Roof Control
Program & Plans

A review has been conducted of your request dated December 5, 2005, concerning second mining of the lower bench of the Middle Kittanning coal seam of the A2-Panel area at the Sago Mine, I.D. No. 46-08791.

Sago Mine

DRAWING NO. 3
TYPICAL CUT SEQUENCE
FOR SECOND DEVELOPMENT WORK
SAGO MINE

DIAGRAM #1

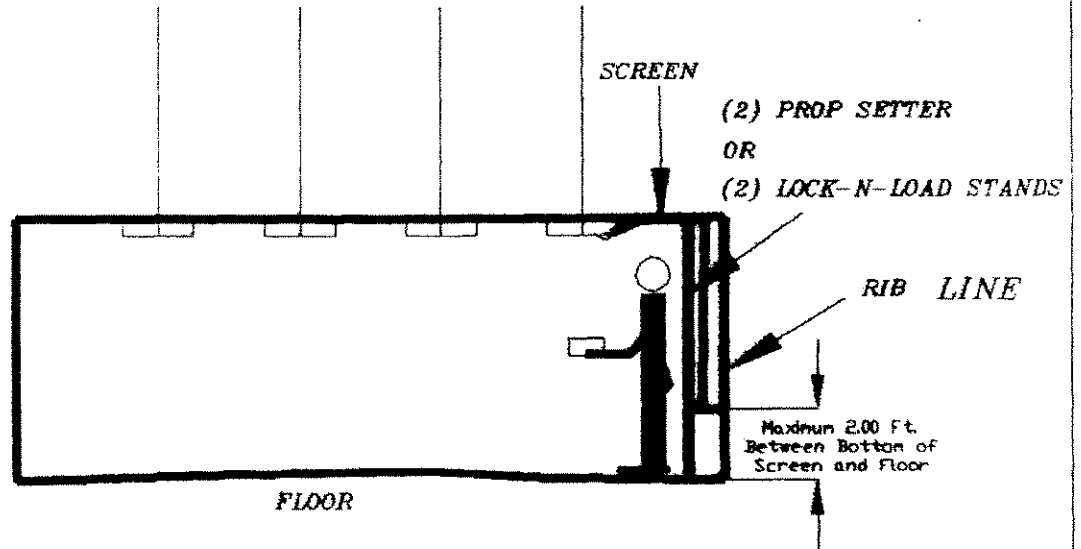
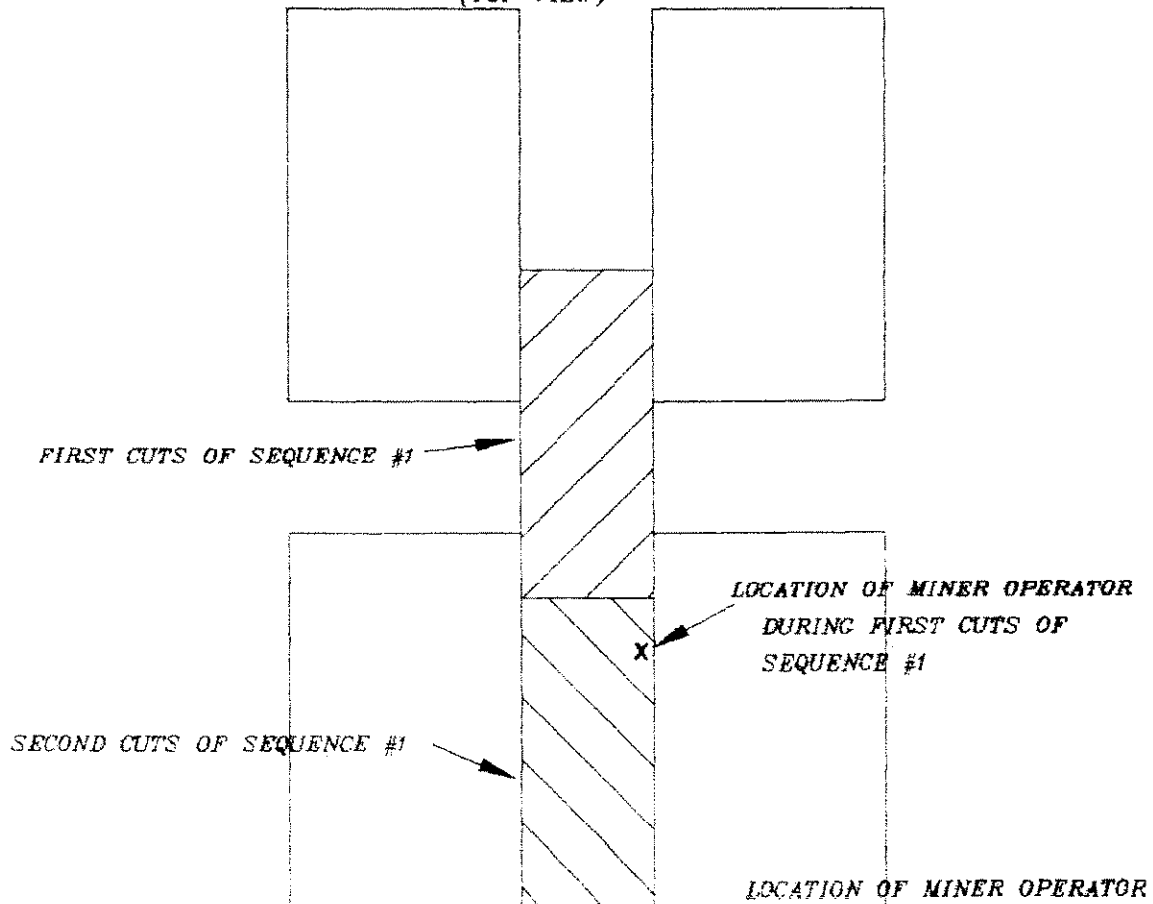
13. Outby the line depicted as "A" on the attached map, additional rib/roof support will be added so as to provide additional roof support for the miner operator. This will be accomplished utilizing one of the methods shown below:

14. During the first cuts of Sequence #1, (See Diagram #1), the continuous miner operator can be positioned inby the corner of Sequence #1, provided the following measures have taken place:

A tentative approval of your request is granted pending an on-site evaluation by MSHA personnel. The enclosed material has been added as a supplement to the mine roof control plan.

RIB STABILIZATION PLAN
STRATA PRODUCTS - LOCK-N-LOAD
(TOP VIEW)

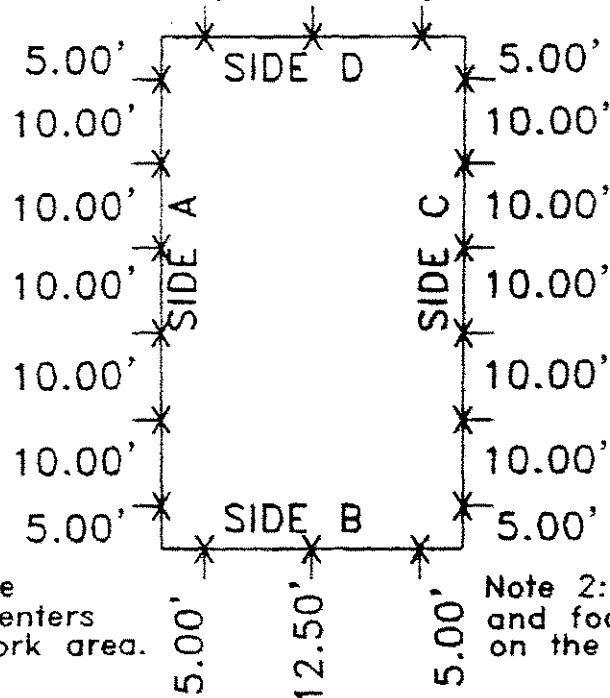
Note 1: Posts will be installed on 4 Ft. Centers in the immediate work area.

TEST AREA FOR 2ND LEFT MAINS AREA SAGO MINE

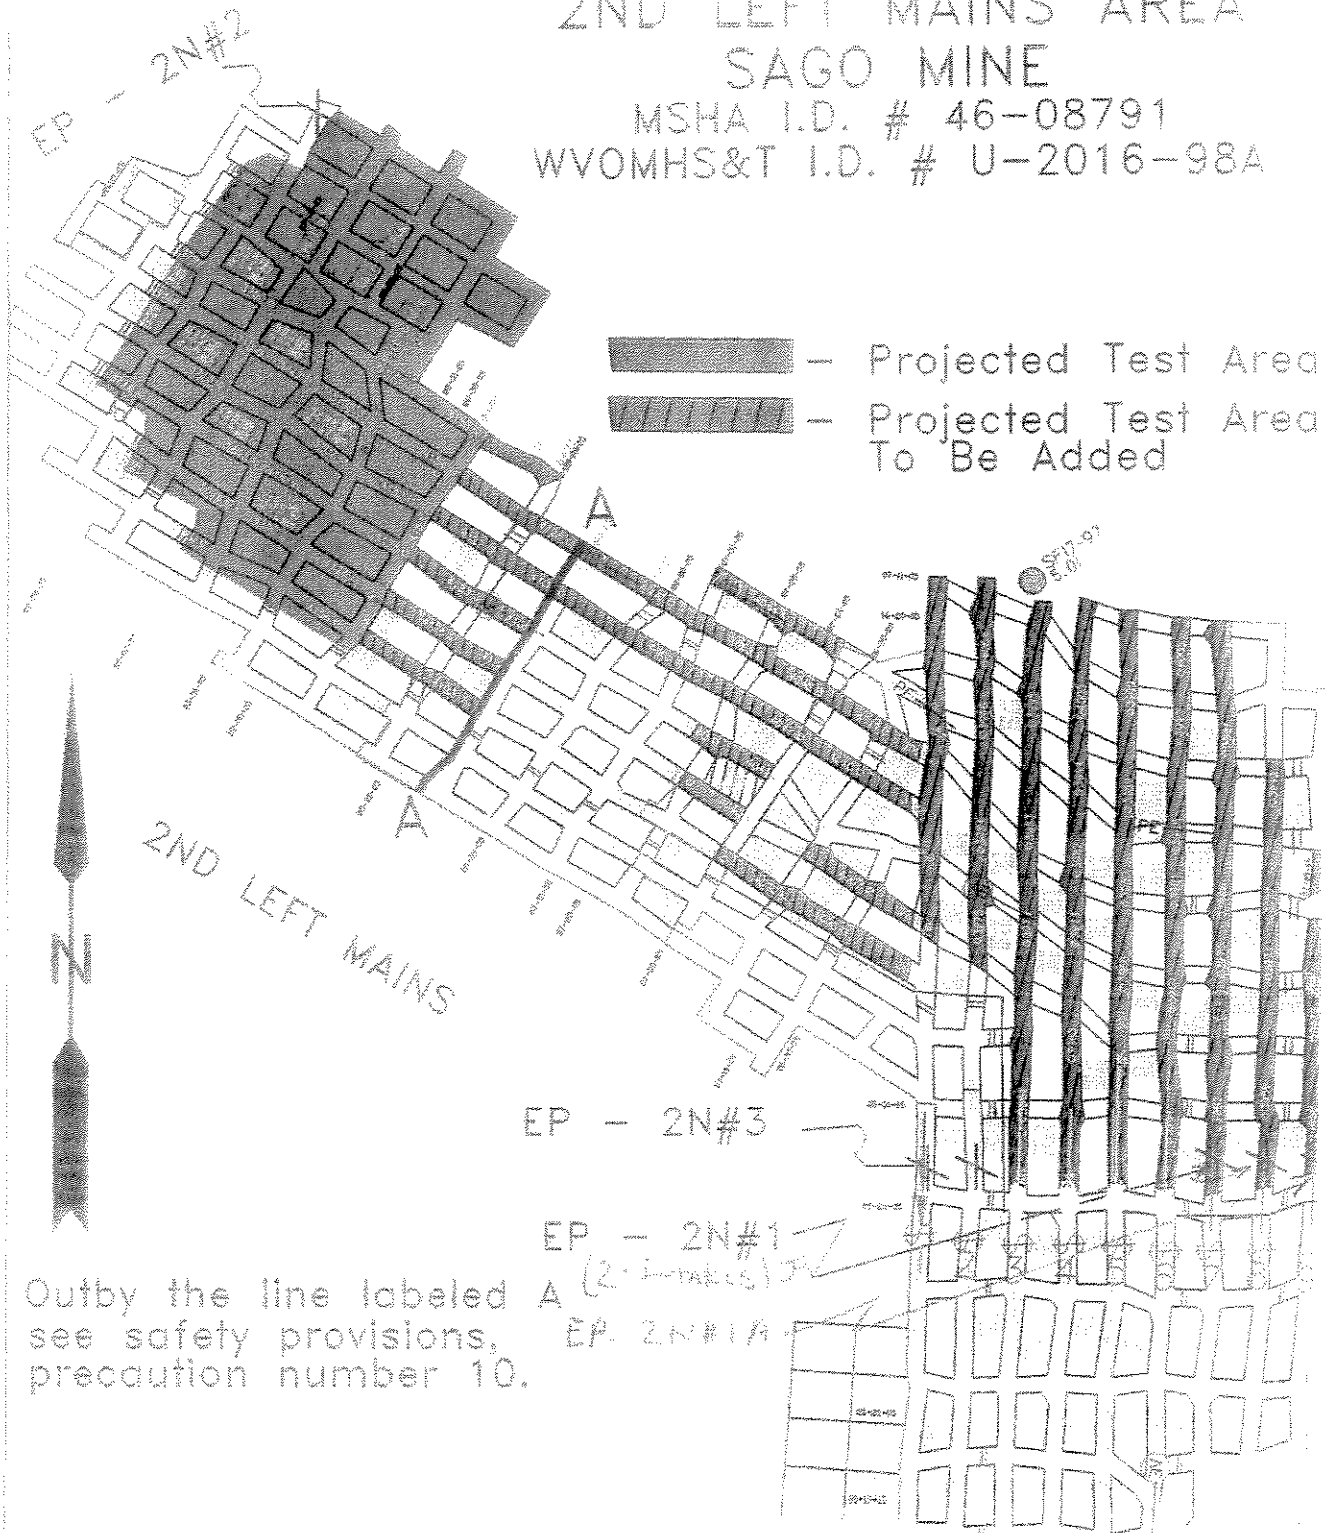
10. Outby the line depicted as "A" on the attached map, additional rib/roof support will be added so as to provide additional roof support for the miner operator. This will be accomplished utilizing one of the methods shown below:

Line A runs from the top left corner (Room # 8, 9, 10) and runs to the bottom right corner (Room # 10, 11, 12) and runs to the bottom right corner (Room # 10, 11, 12) and runs to the bottom right corner (Room # 10, 11, 12).
